Ministerial Referral: TPM-2014-9/A
Amended Batmans Hill Development Plan, 614-666 Flinders Street,
Docklands

1 December 2015

PLANNING REPORT MINISTERIAL REFERRAL

Application number:	TPM-2014-9/A
Applicant / Owner / Architect:	Lend Lease / Places Vic / Aspect Oculus
Address:	614-666 Flinders Street, DOCKLANDS VIC 3008
Proposal:	Amended Batman's Hill Development Plan
Date received by City of Melbourne:	9 November 2015
Responsible officer:	Blair Mather

Figure 5.3 Proposed max wind criteria

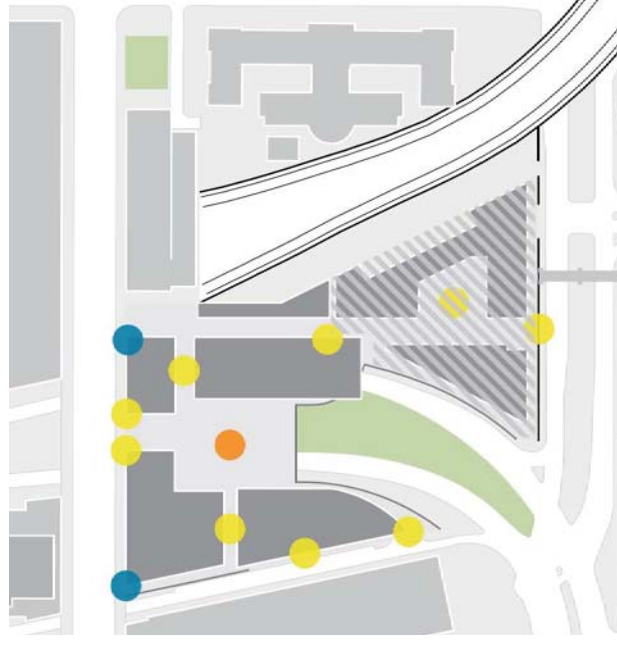
In analysing these findings, it is noted that the amended Development Plan achieves all of the wind criteria as noted in the 2014 Development Plan, and in some cases provides improved conditions.

FIGURE 4 AND 5: EXISTING AND PROPOSED BUILT FORM LAYOUT

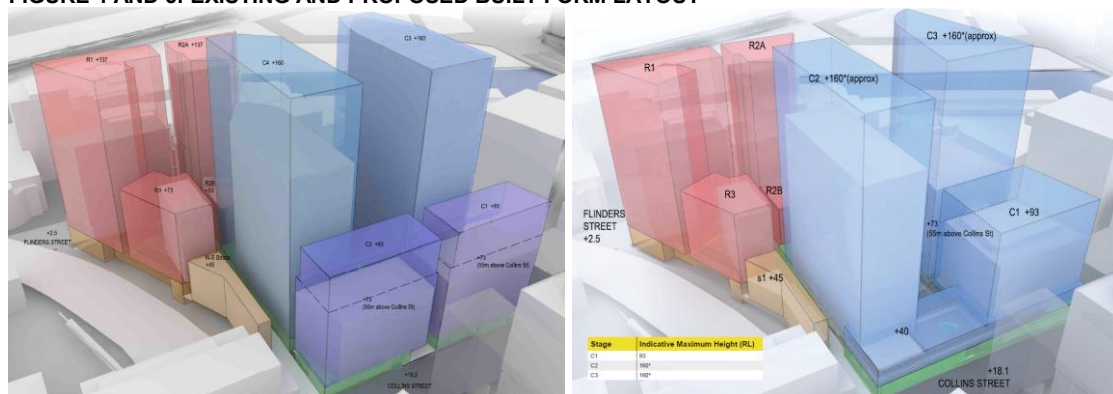
In terms of maintaining the dominant streetscape scale from within Collins Street, the main change is the introduction of a sky garden in lieu of building C2, which would be the visually dominant element.

At 22 metres and 55 metres in height (above Collins Street), the proposed sky garden and Commercial Building C1 provide a lower presence to Collin Street which relate well to the adjacent proposed Lantern building fronting the Goods Shed South and Media House (approx. 41 metres and 52 metres high respectively). This aspect of the design is commensurate with the height of existing and proposed multi-storey development in the vicinity of the site.

One of the key benefits of the amended composition and the provision of the Sky Garden is the clear graduation of heights with a lower presence to the street which would provide for pedestrian amenity (wind, pedestrian scale, smaller tenancies).

The proposed sky garden will continue to provide an effective transition between the higher towers and the lower form of the Lantern/Goods Shed building and the Age Building and the buildings further south on the opposite side of Flinders Street.

Overall, it is considered that the revised built form composition is acceptable subject to the inclusion of appropriate setbacks as discussed below – It is important to note that the detailed design of each building will occur as part of a formal planning permit application and be subject to a separate assessment. The final height of the buildings will require careful consideration taking into account a number of matters including access to sun and daylight, wind conditions, internal and external amenity impacts and environmental sustainability.

FIGURE 6 AND 7: EXISTING AND PROPOSED BUILT FORM ENVELOPES

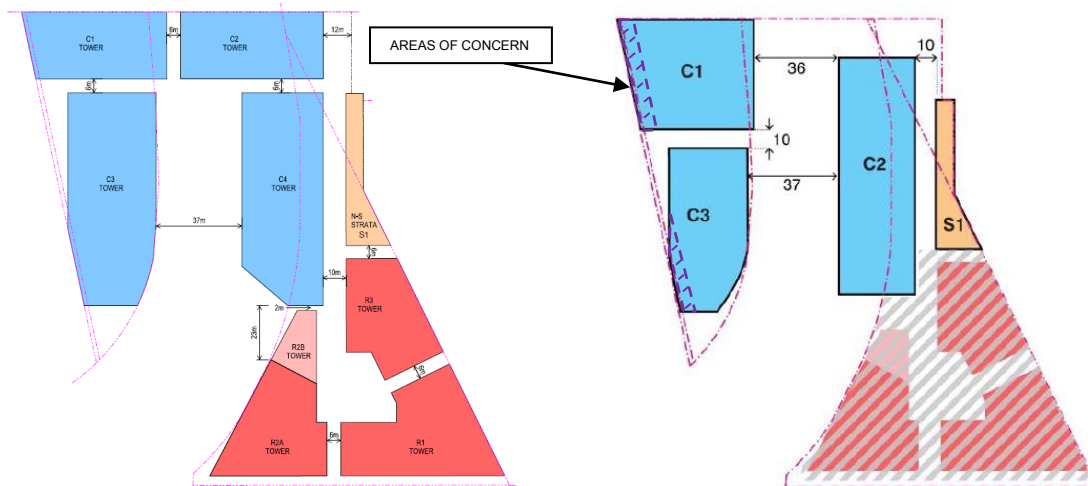
The proposed setback between buildings also requires careful consideration. The East/West lane at 6.0 metre width is acceptable with a low rise 'podium' built form to approximately 40 metres shown as 'possible massing' on C1/C3; however, if C1/C2 were to be built to maximum envelop of 93m height then the 6m width would be unnecessarily narrow. It is therefore recommended that buildings fronting a laneway incorporate additional setbacks above 40 metres in height, to retain access to daylight and ensure a sense of openness that reinforces a human scale.

The presentation to Aurora Lane is a critical interface. Currently Aurora Lane is one sided with the heritage Goods Shed on its western side and the open expanse of Wurundjeri Way, and its large volume of traffic on the opposite site. There is no containment creating a typical lane.

The endorsed Development Plan proposes completing Aurora Lane with a three to four storey built form, along its eastern side conceived as an active edge screening car parking and services and occupied by strata offices. The amended Development Plan fails to deliver on this promise and instead allows Building 'C1' to be constructed to a maximum height of 70 metres with no setback to Aurora Lane. Together with building C3, the buildings will create a blanket wall of glass with limited articulation and only a small break in the built form to allow for Marketplace Lane.

Finally, the setback of Building C2 from Collins Street appears to encroach into the location of the proposed Sky Garden and contradicts other illustrations provided within the development plan documentation. Whilst this is not problematic in itself, the reduced setback results in the inclusion of a roof cover over Marketplace Lane which would result in an artificial, retail mall/ private domain, rather than a public domain as envisaged by the Endorsed Development Plan and expected of 'public' spaces – this aspect of the proposal is not supported and is discussed further below.

intimate scale of buildings on the opposite side of Aurora Lane, included the Heritage Listed Goods Shed. It is recommended that the setback to Aurora Lane be retained generally in accordance with the earlier concept plan layout, identified in figure 8 below.

FIGURE 9: EXISTING AND PROPOSED BUILDING ACTIVATION AT GROUND LEVEL

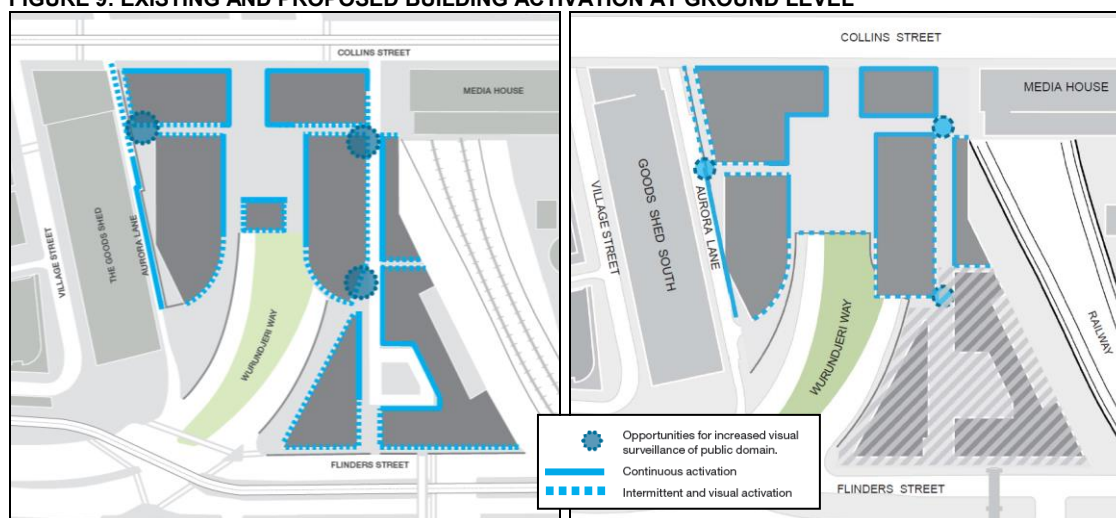
The building activation at ground level is detailed page 16 of the supplementary development plan documentation, which is reproduced below as figure 9.

The proposal results in a net improvement in the provision of active frontages throughout the development plans area and it is expected that continuous activation will continue to be provided at the interface between built form and the key public areas while intermittent and visual activation is used elsewhere.

The amended Development Plan proposal seeks to truncate Marketplace Lane into two short connections. The full activation of the eastern section of Marketplace Lane is supported; however, the lane is proposed to be fully enclosed to the sky which makes for an artificial retail mall/ private domain, rather than a public domain as envisaged by the endorsed Development Plan and expected of 'public' spaces.

FIGURE 10 AND 11: EXISTING AND PROPOSED ACCESSIBLE PATHS

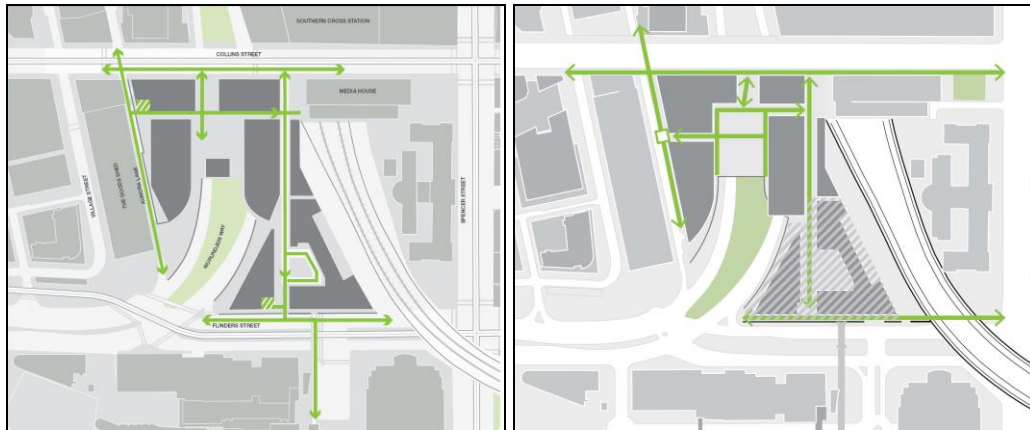
The approved and proposed accessible paths throughout the site are detailed in Figure 10 and 11 below. The public lifts, on Flinders Street and Aurora Lane, are considered integral to the overall plan as they provide an alternative to the stairs. The amended plan retains the two lifts albeit with the Aurora Lane lift location slightly south of the originally proposed location.

As the design progresses, the development must ensure accessibility, not only for people with disabilities, but also the elderly, people with temporary disabilities, parents with strollers or children and bicycle riders.

FIGURE 15: PROPOSED SKY PARK ILLUSTRATION

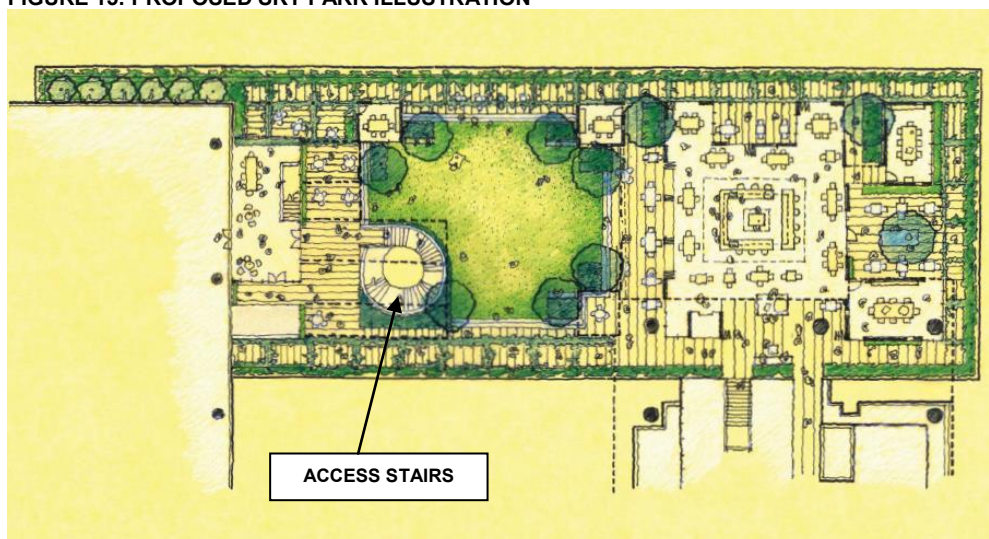
Overall, it is considered that this space should be recognised as public space offering for the broader Docklands community as a whole and the design should ensure that local residents and workers are welcomed and encouraged to use this space. To this end, it is recommended that a direct connection between the plaza on Collins Street and the sky garden (that is visibly prominent and easily accessible from Collins Street)

be provided to ensure that this space is inviting to a broader group of people and users (as depicted in figure 15 below), and not just focused on the occupants of the Melbourne Quarter.

Some concern has also been expressed regarding the likelihood of the proposed planting to succeed in this location, particularly given the exposed nature of the site and the limited opportunity for any significant soil depth.

Further detailed design is required at the planning permit stage, demonstrating how the vegetation has a good chance of thriving – this should include the provision of a detailed landscape plan with species, irrigation plans, proposed soil depths, drainage, details of seating, furniture and lighting.

- A direct connection between the plaza on Collins Street and the sky garden (that is visibly prominent and easily accessible from Collins Street) must be provided to ensure that this space is inviting to a broader group of people and users, and not just focused on the occupants of the Melbourne Quarter. The spiral stair that is illustrated in the development plan on page 7 provides such a connection.

FIGURE 15: PROPOSED PUBLIC REALM OWNERSHIP

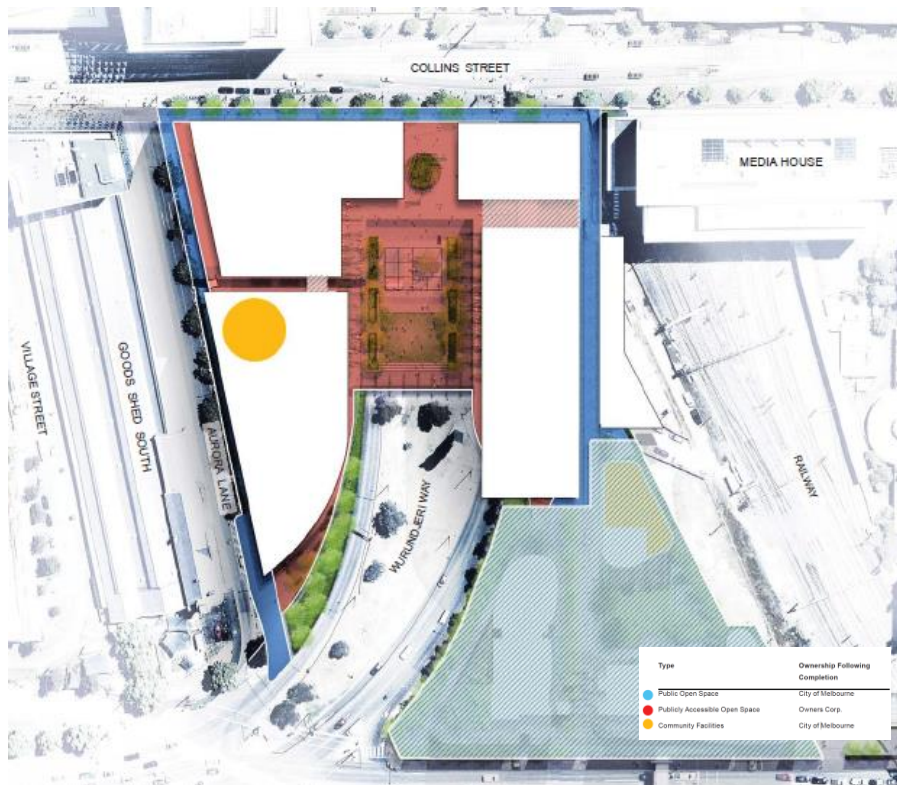
The public realm ownership plan at Figure 15 is generally in accordance with the advice provided by Council and is satisfactory; however, no details have been provided with regard to the future community facility and further details will be required as the next phase of the design process is advanced.
